DETAILED ACTION

This is the first Office Action for application number 10/626,101, Suction-Adhesive Device, filed on 7/23/03. Claims 1-20 are pending. This application claims priority to Hong Kong Reg. 02105663, dated 8/1/02 and Hong Kong Reg. 03102213.4, dated 3/26/02.

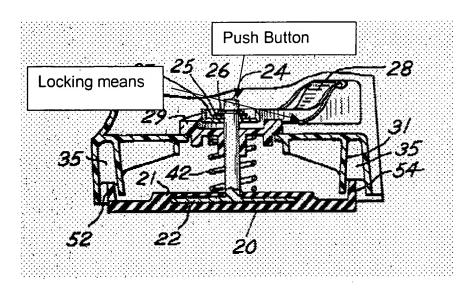
Claims 1-6, 9-14 and 17-20 are rejected under 35 U.S.C. 102(b) as being anticipated by United States Patent No. 3747170 to Kieves.

The patent to Kieves discloses a suction cup (20), a stem (24) extending from the suction cup (20) with a pushbutton (tip of 24, See Drawing), a body (21) having a neck through which the stem extends, a spring (42) interacting with the stem and the body, and a visual indicator ring of contrasting color (26) which protrudes beyond the neck of the body when the spring has drawn the suction cup (20) toward the body (21), the washer may be a different color metal than the stem) fixed and integral with respect to the stem, a locking means (28, 29, 32 See Drawing Below) interacting with the body and interacting with the locking means (28, 29, 32).
